September 10, 1997

3435.00-005

Subject: Response to Chiron Comments for the Site Investigation Workplan
Sherwin-Williams Facility, Emeryville, California

A-Zone Groundwater Elevation Map,
July 29, 1996

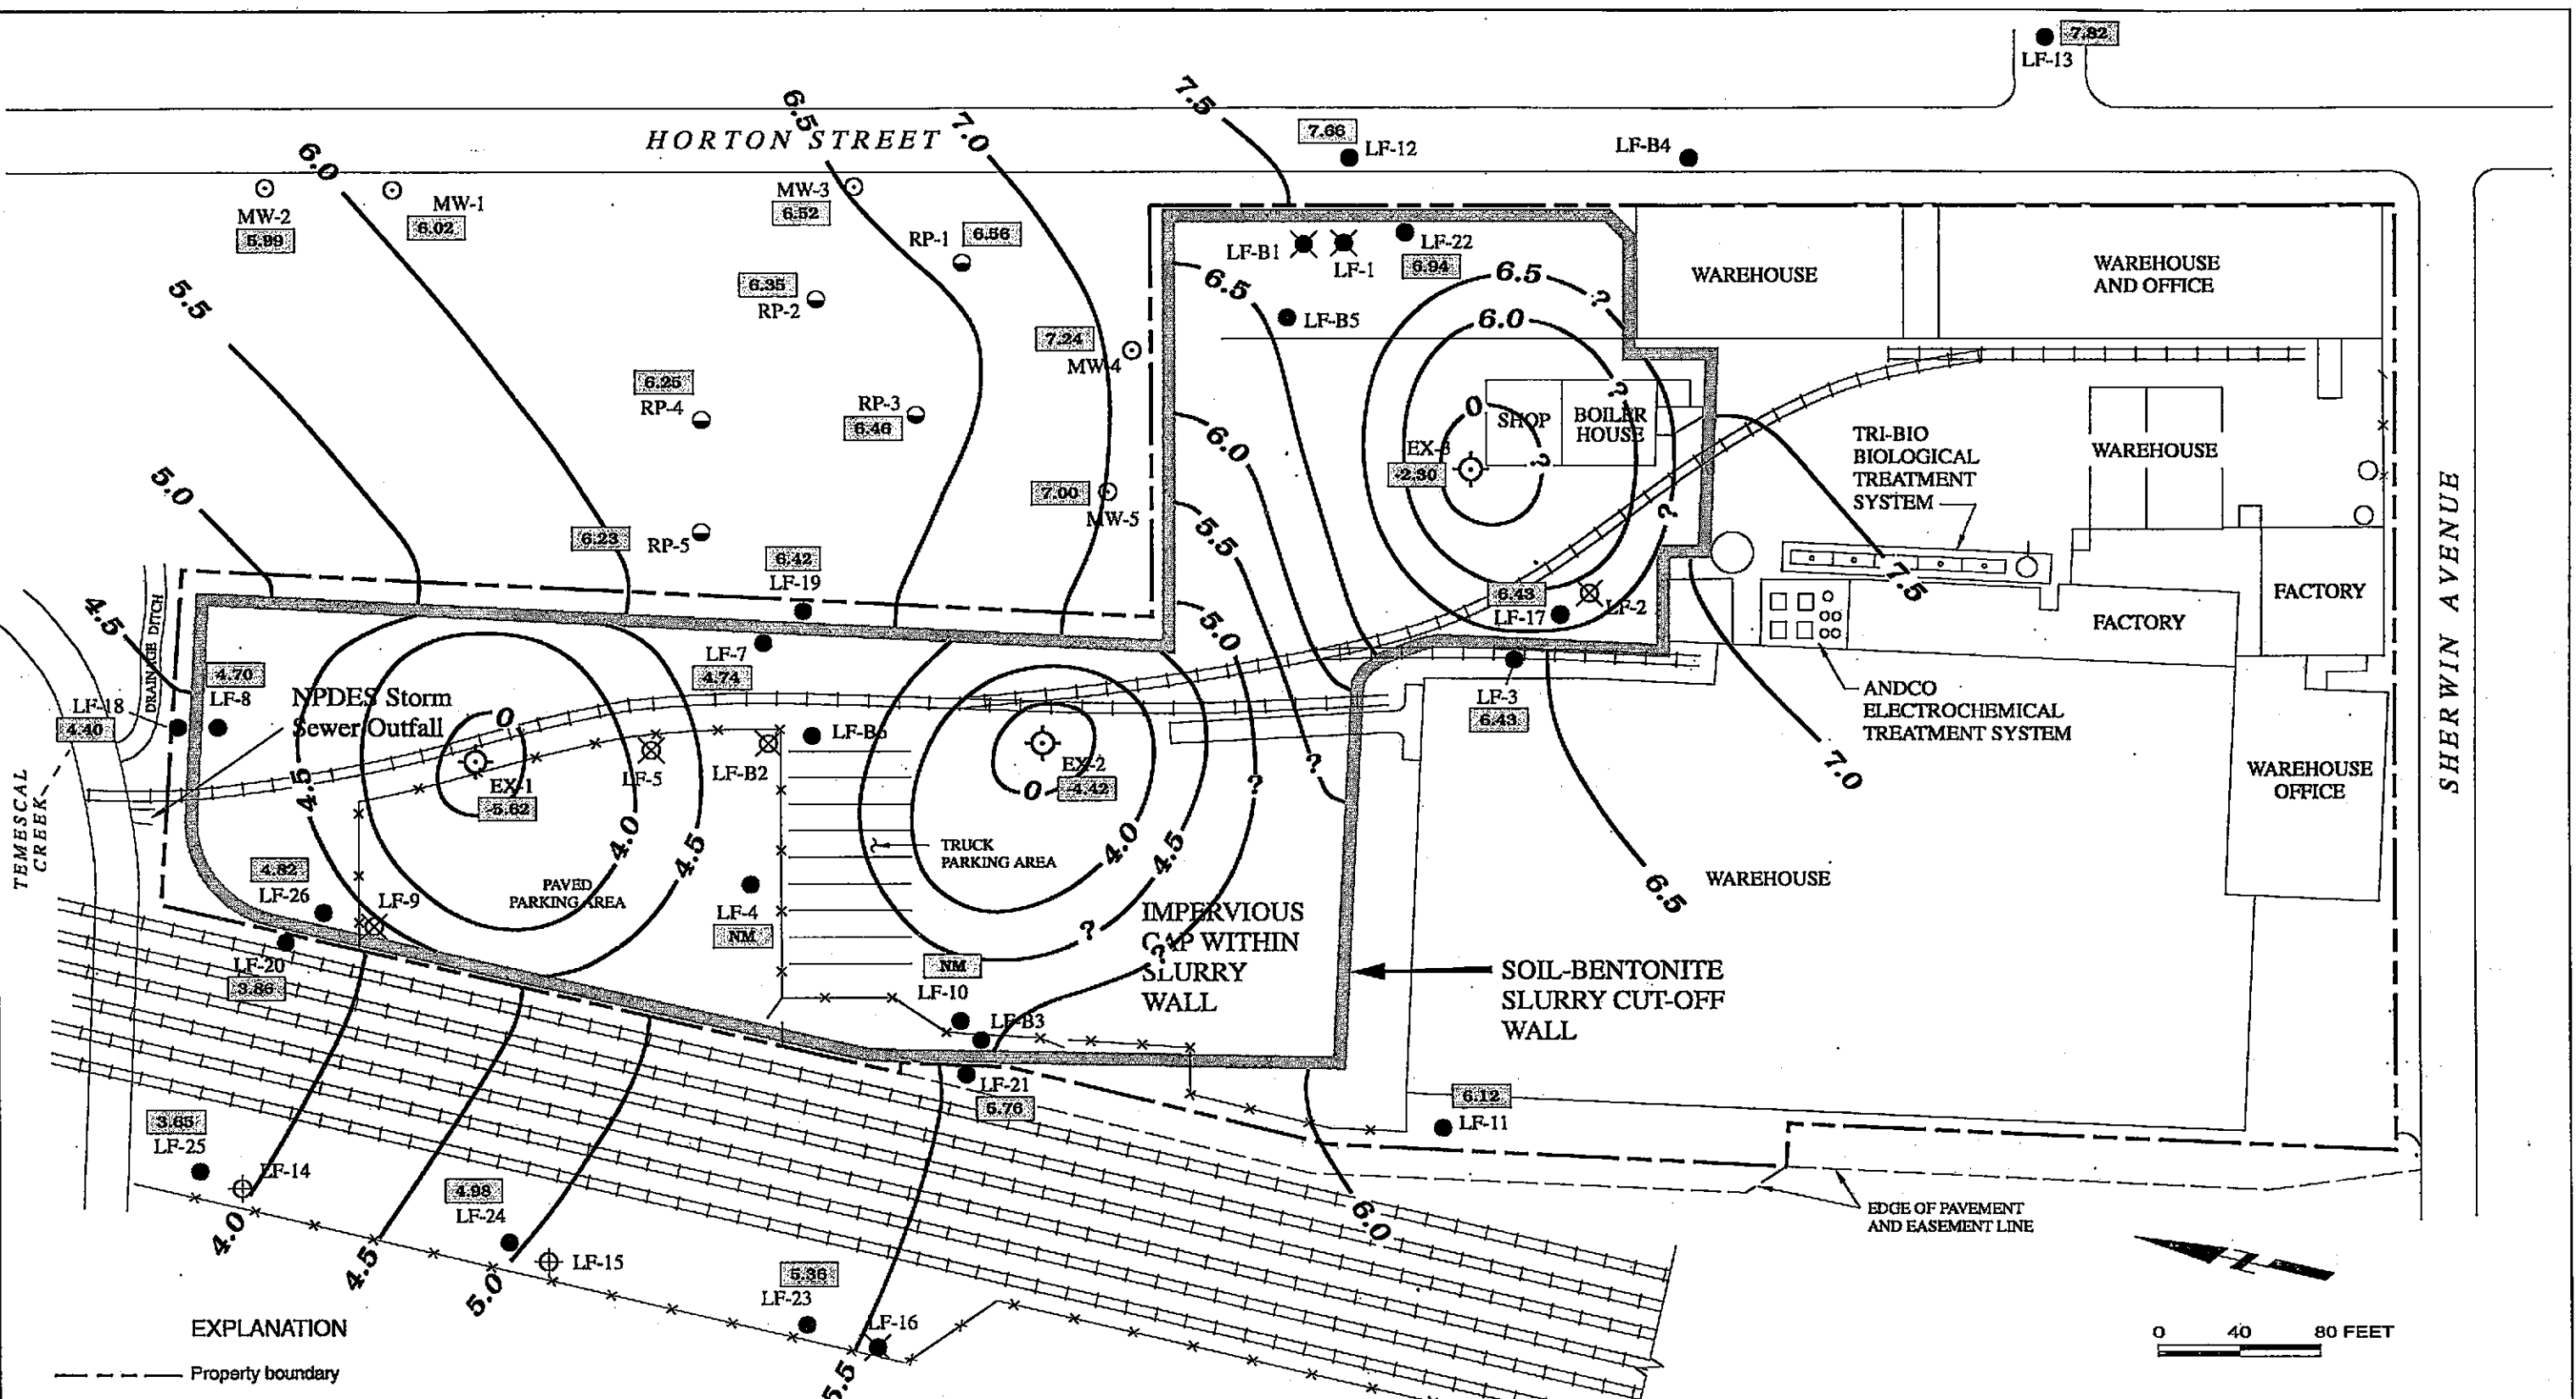
Some of the recent issues with respect to outward hydraulic gradients have related to a possible source of water within the slurry wall and intermittent operation of the system during the first half of 1997. The system can be very effective in maintaining lower water levels within the slurry wall as evidenced by past data showing the hydraulic gradients during a period when a water source was not apparent and the system operated more continuously (see Attachment A). The following actions have been or are currently being taken to address the current issues relating to water levels within the slurry wall:

Photo of Sherwin-Williams and
South BGR Property

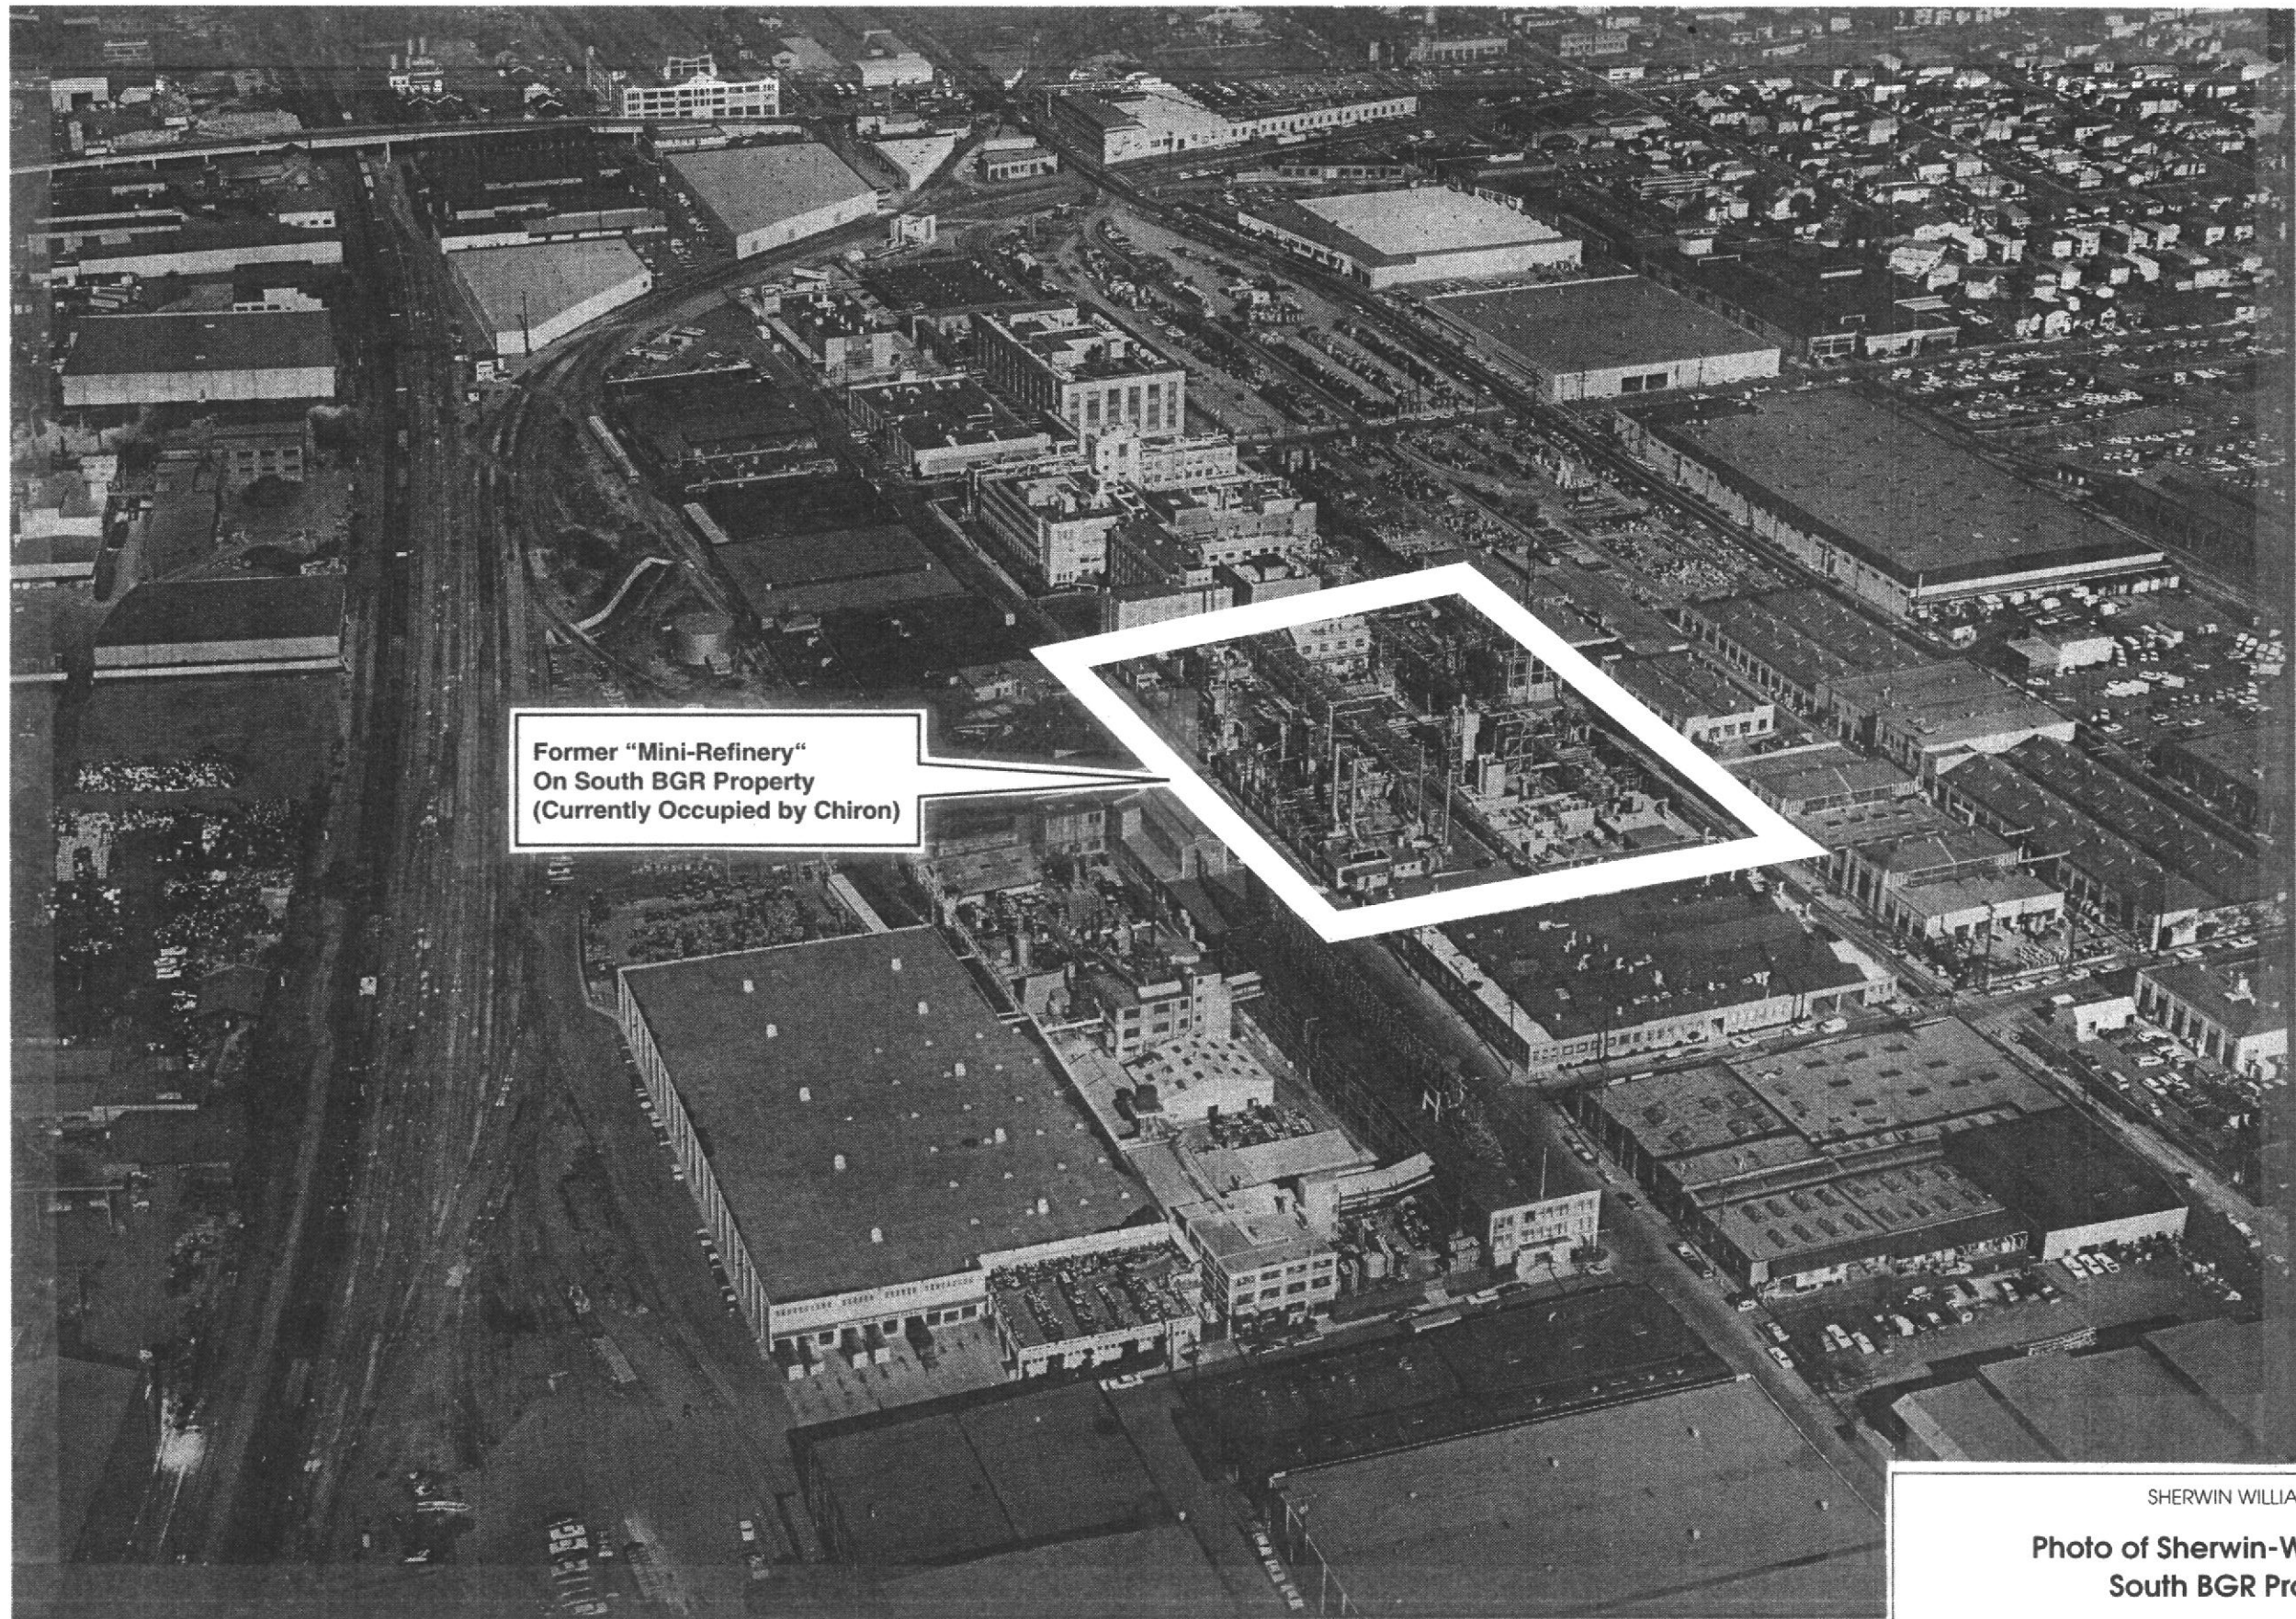
- The south BGR was a former Shell development facility and aerial photos clearly show significant past industrial operations on that property, including what appears to be a "mini-refinery" (see Attachment B). The former Shell development site was a petrochemical research facility that operated between 1928 and 1972. In addition, past groundwater plume maps that were prepared by EKI clearly show a source of arsenic from the former Shell development facility (see Attachment C).
